Town of Montgomery Police Station

ADDENDUM #3: April 25, 2025

1 FIRST FLOOR PLAN
1/4" = 1'-0"

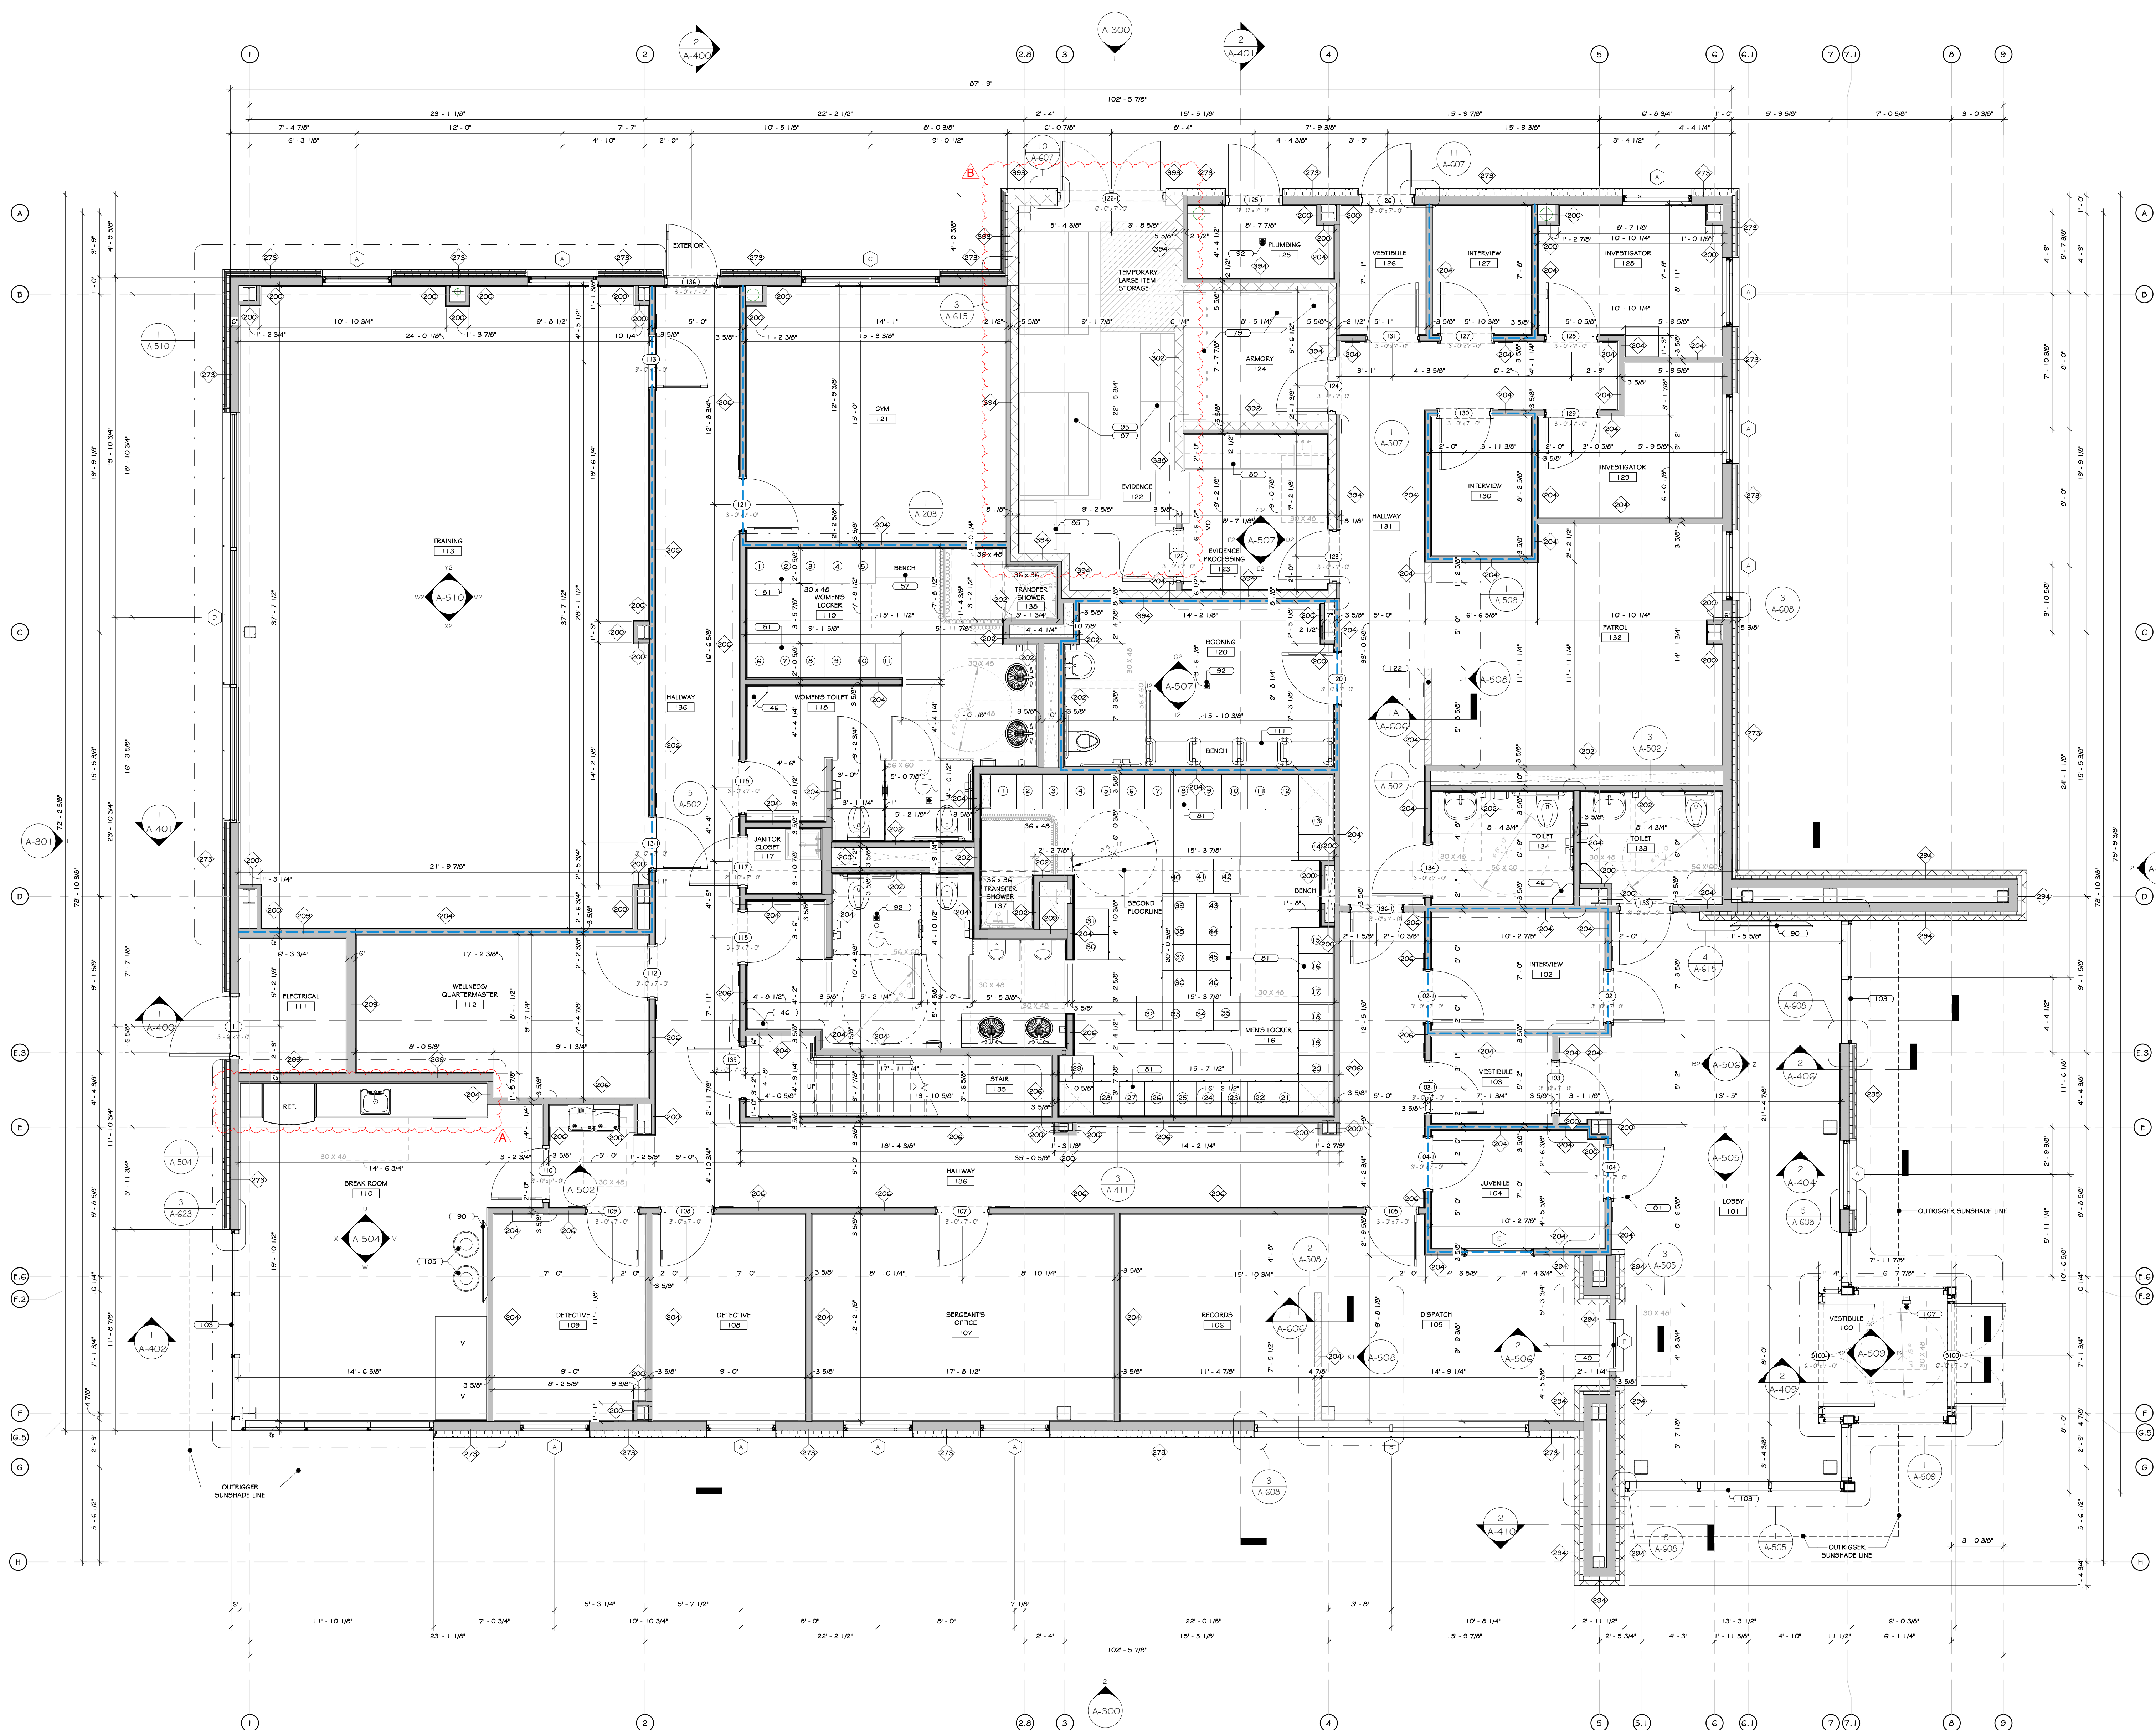
5. **As a notification**, A-201 - First Floor Plan, A-700 - First Floor Finish Plan, A-703 - First Floor Paint Plan, A-800 - Doors & Window Schedule, A-900 - First Floor Furniture Plan, A-902 - Interior Sign Schedule, and A-903 - First Floor were updated.

Drawing: DOORS & WINDOW SCHEDULE

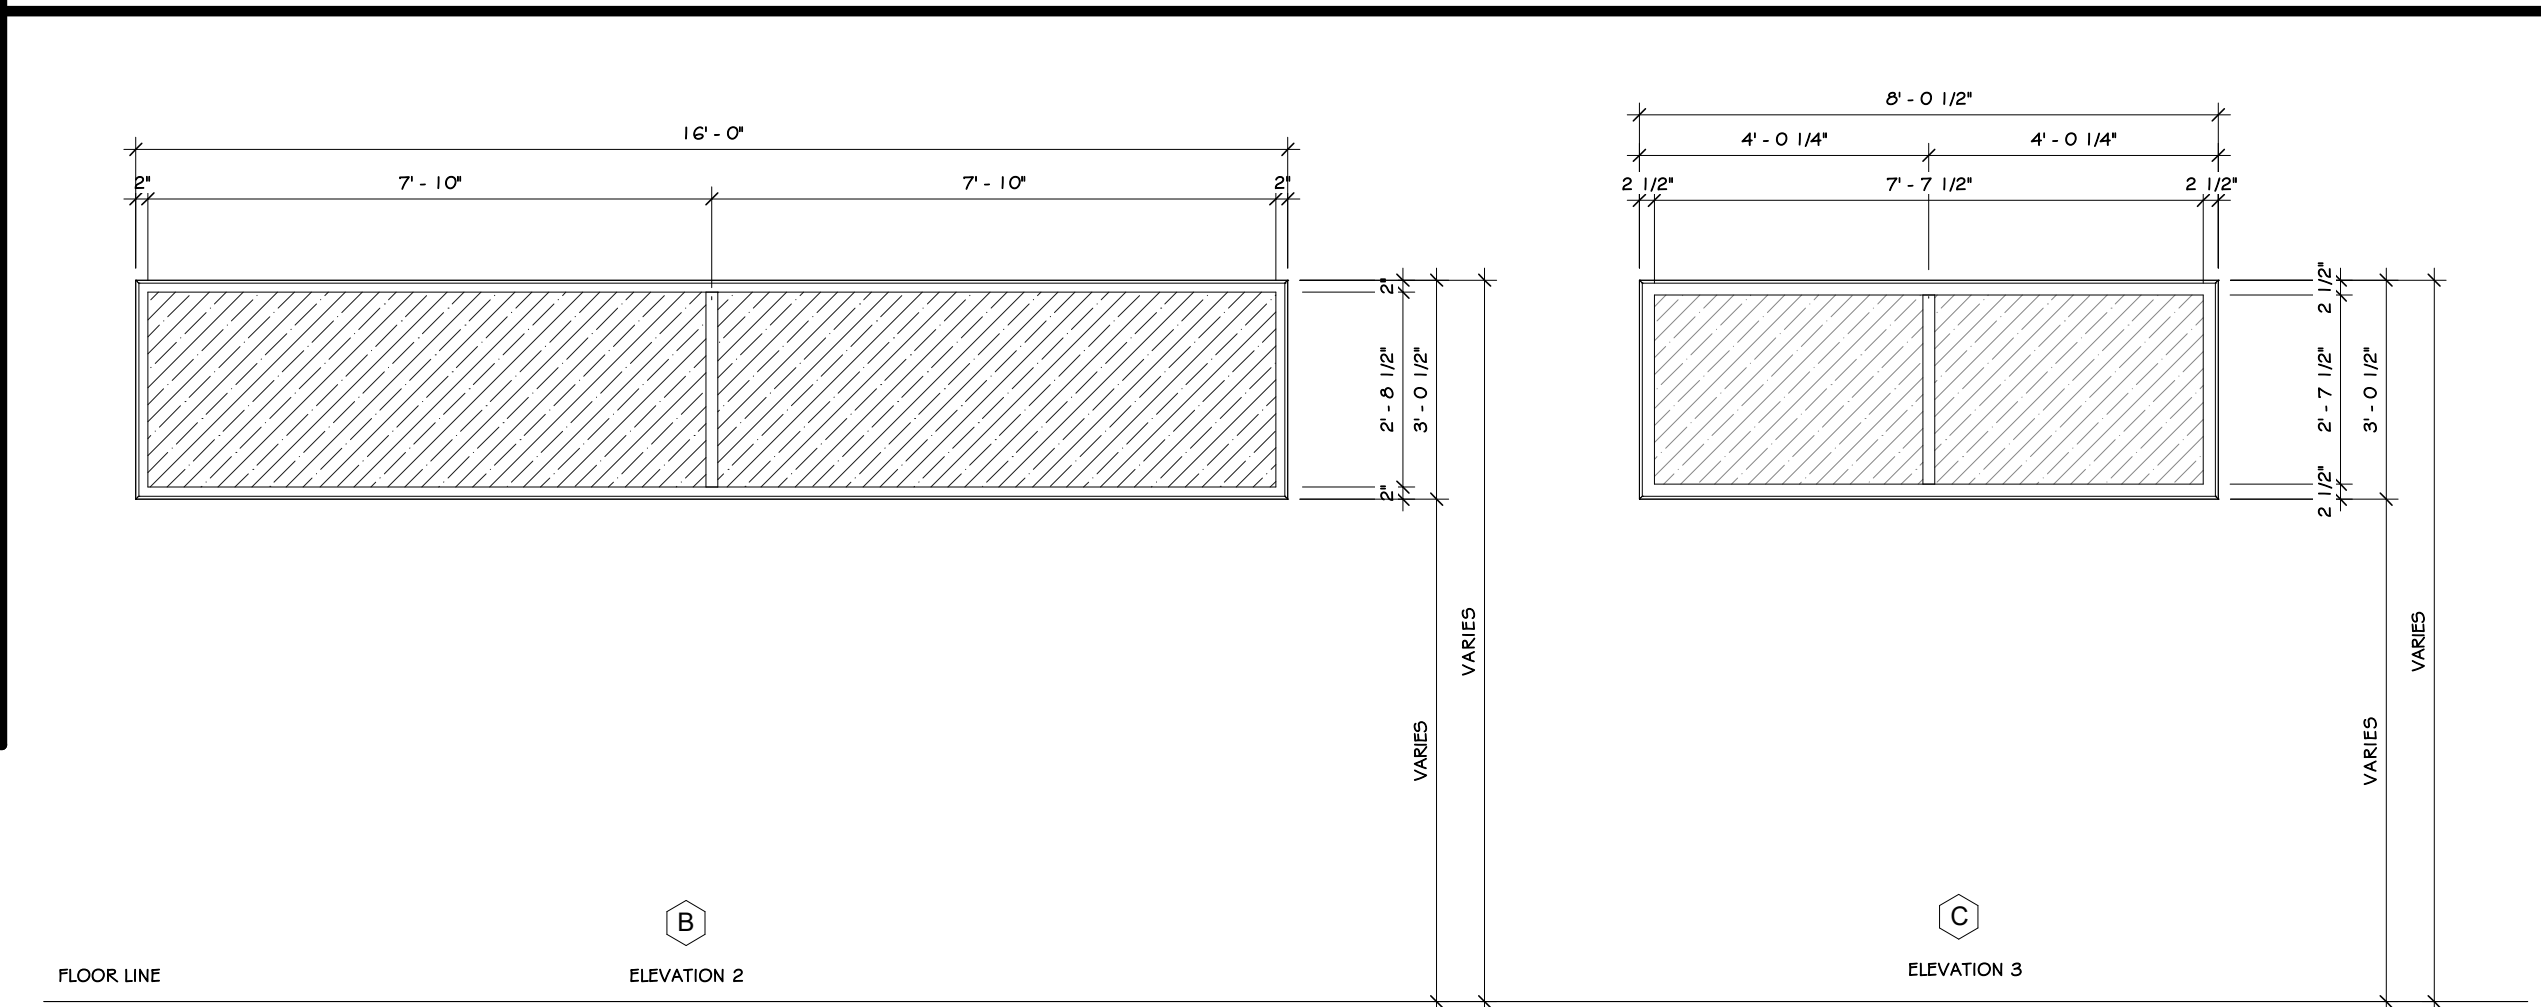
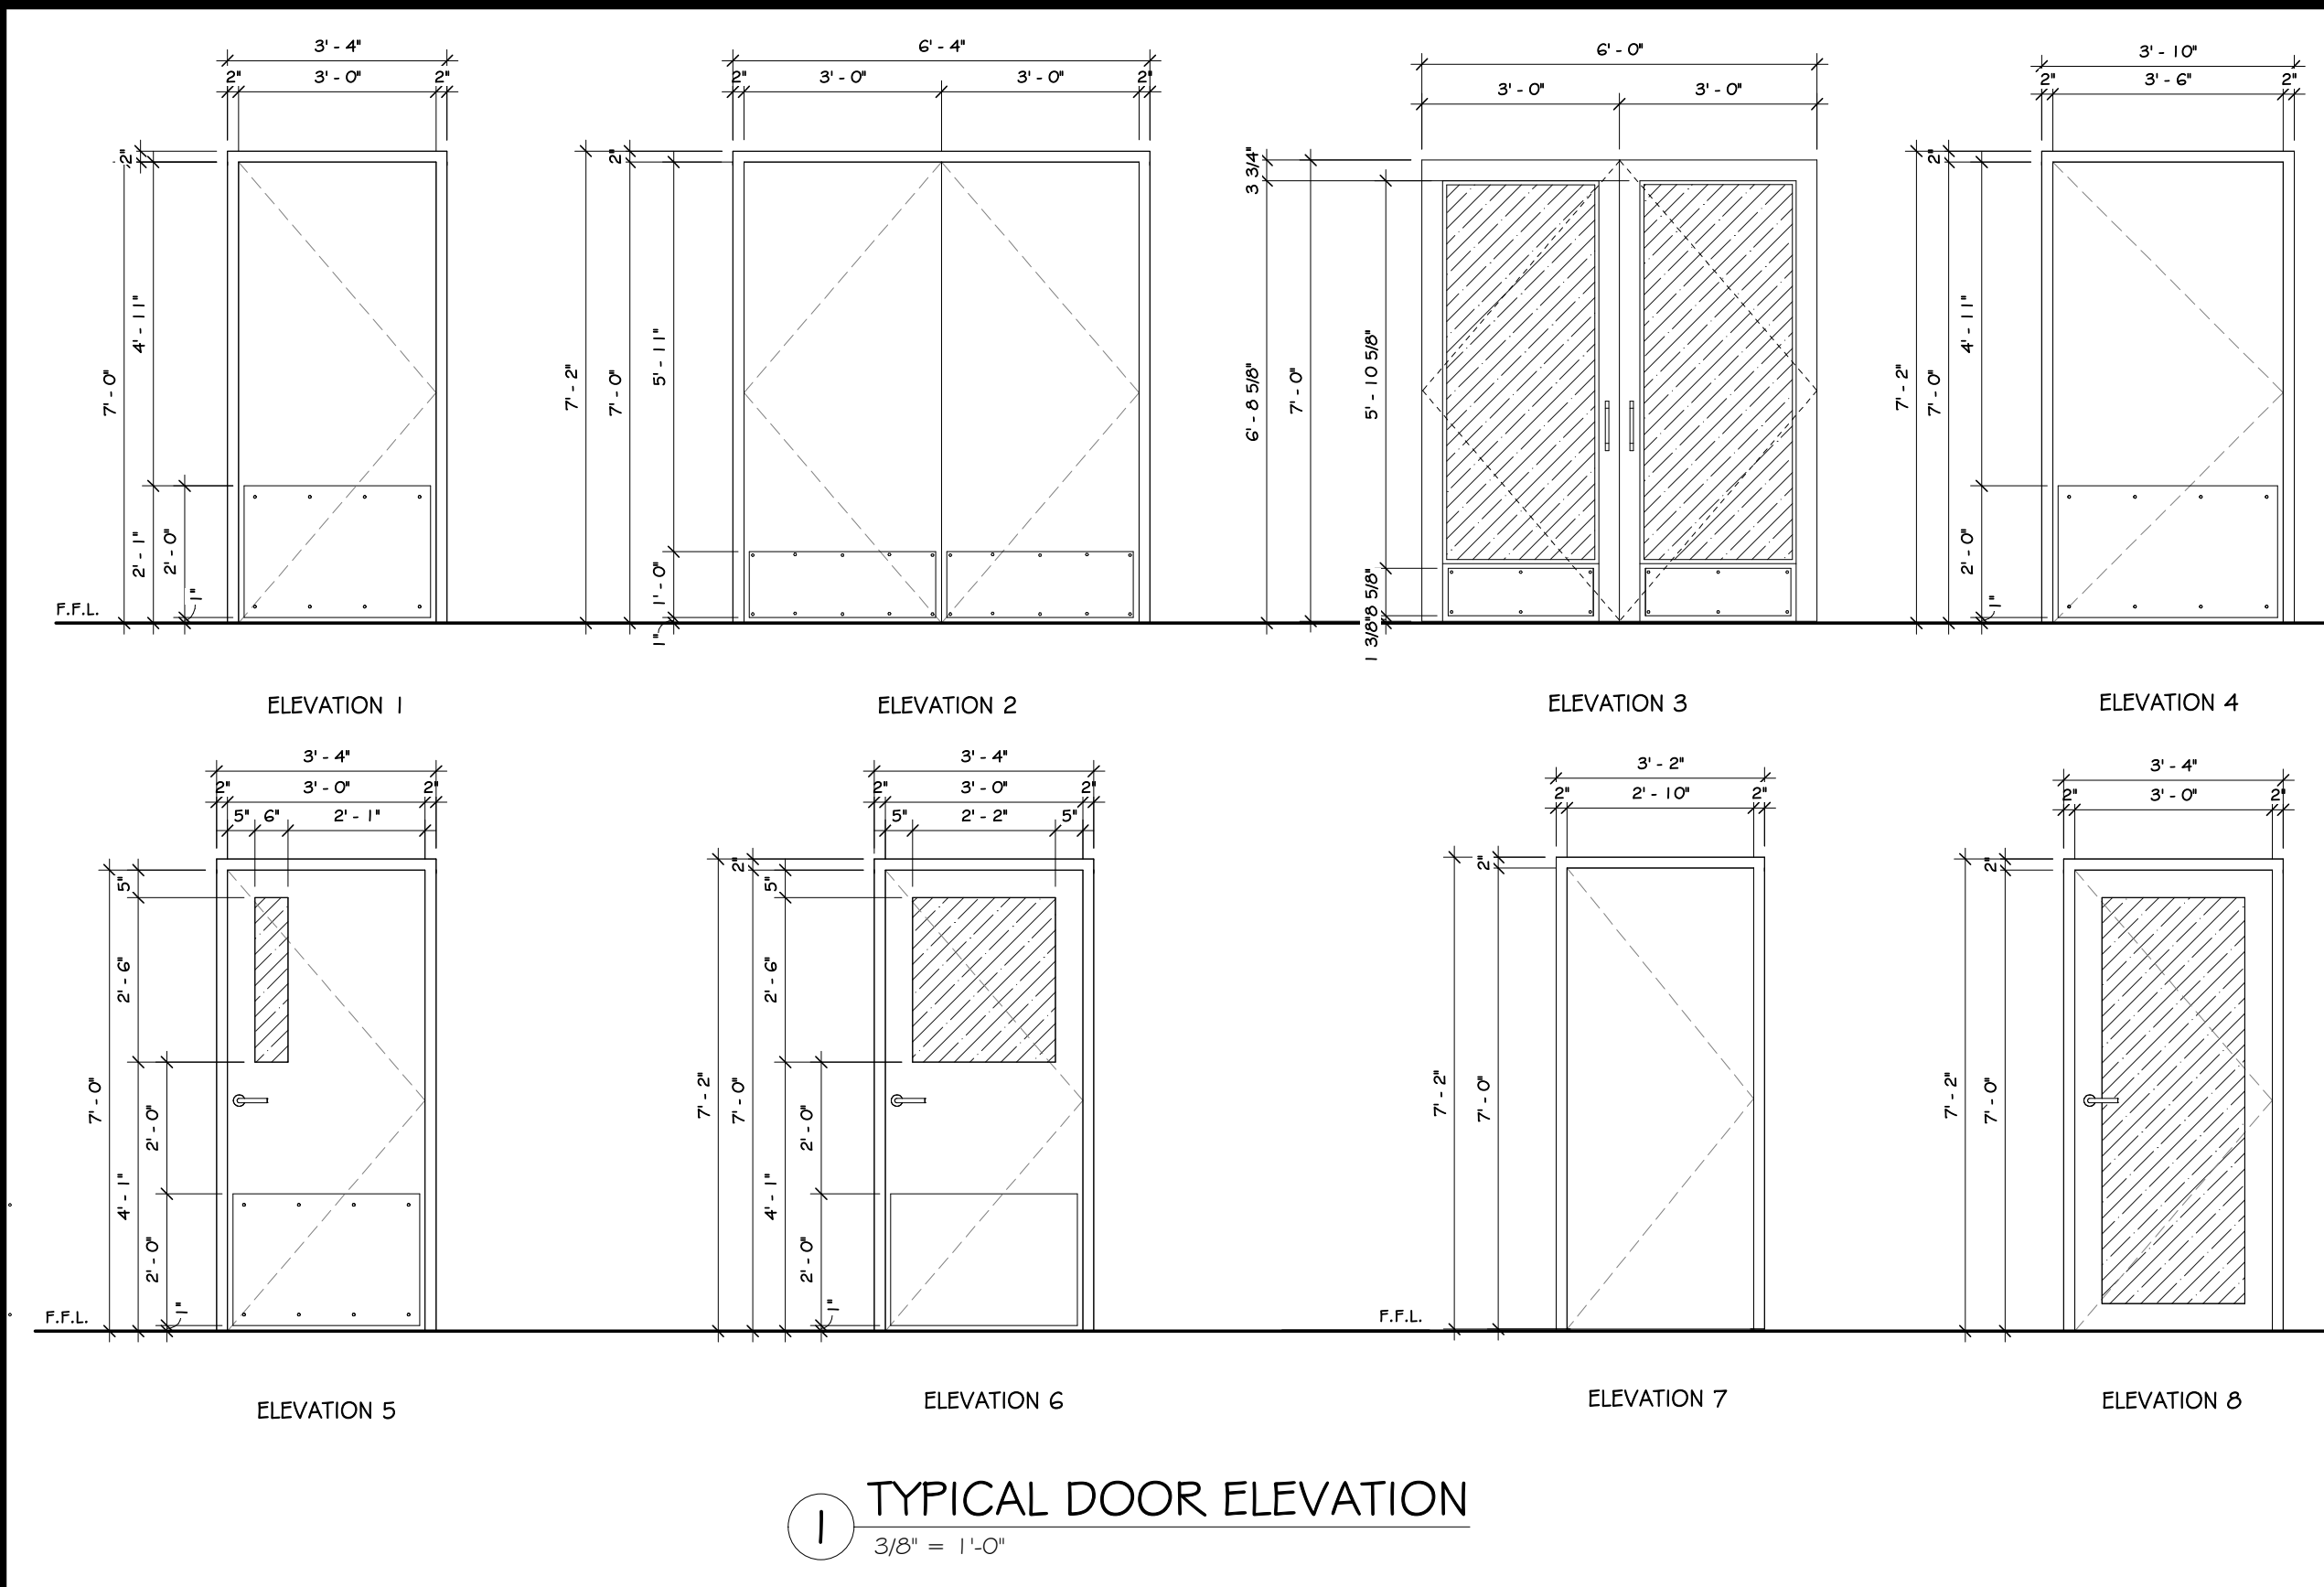
13. Drawing A-800 depicts Typical Door Elevations which are not keyed into the Door Schedule. Please advise.
RESPONSE: Drawings A-800 has been revised and is attached to this addendum.

Question, there is no section 01 21 00 Allowances.
RESPONSE: There are no allowances for this project.
40. Please clarify Door schedule on A-800 door type column.

RESPONSE: Drawings A-800 has been revised to clarify the door elevation numbers.
41. Details 1 & 2/A-608 appear to show horizontal sliding windows. Please confirm all windows on the project are fixed.
